South Texas Project Electric Generating Station, P.O. Box 287, Wadsworth, Texas 77483

May 22, 2014  
NOC-AE-14003103  
10 CFR 50.12  
10 CFR 50.90

South Texas Project  
Units 1 & 2  
Docket Nos. STN 50-498, STN 50-499  
First Set of Responses to April, 2014, Requests for Additional Information  
Regarding STP Risk-Informed GSI-191 Licensing Application - Revised  
(TAC NOs MF2400 and MF2401)

Figure 1. ECCS success (green) and failure (red) as a function of break size. Blue dashed lines mark the smallest break that can challenge ECCS performance metrics and the largest break that can pass ECCS performance metrics.

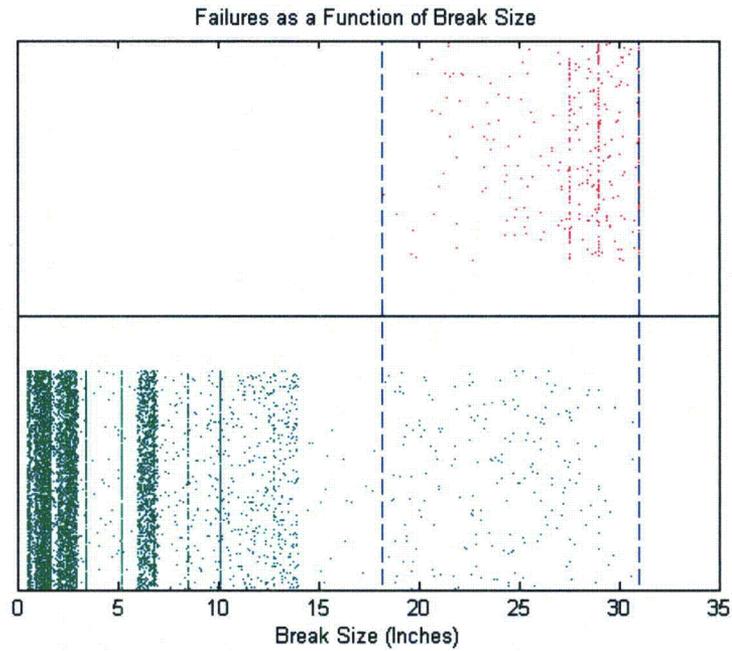
**PRA models often include high and low pressure recirculation in event trees for small LOCAs. Please explain how it was determined that only medium and large LOCAs would require sump recirculation. Also, please explain why there were no failures for small or medium LOCAs, including an explanation of the physical phenomena that led to this result. Please include in this explanation a statement as to whether this result was due to insufficient debris generation or Volume 3, page 81, Assumption 11.**

Since the initial preparation of Volume 2 (LAR Encl. 4-2), it has been confirmed that only large LOCA scenarios are able to challenge ECCS performance metrics at STP as shown in Figure 1. ECCS performance metrics address physical phenomena associated with debris-induced effects on (1) strainer mechanical buckling, (2) NPSH margin, (3) degasification, (4) core fiber inventory associated with blockage for hot leg and cold leg breaks and (5) core fiber inventory associated with onset of boron precipitation for hot leg and cold leg breaks. None of the user-specified thresholds for these performance metrics are challenged by small and medium break scenarios at STP. Because transport fractions and failed coatings sources are largely constant for all scenarios, successful performance of small and medium break scenarios is attributed to smaller insulation debris volume.

LAR Encl. 4-3 (Volume 3) Assumption 11c, page 82 of 248 correctly states that boron precipitation failures were not explicitly precluded for small breaks (either cold leg or hot leg), and in fact, were not precluded for any cold leg breaks. LAR Encl. 4-3 Assumption 11d states that medium and large, and in fact all, hot leg breaks were

precluded from boron precipitation. Assumption 11d contributes to the success states of small and medium breaks, but does not override the dominant consideration of smaller debris volume.
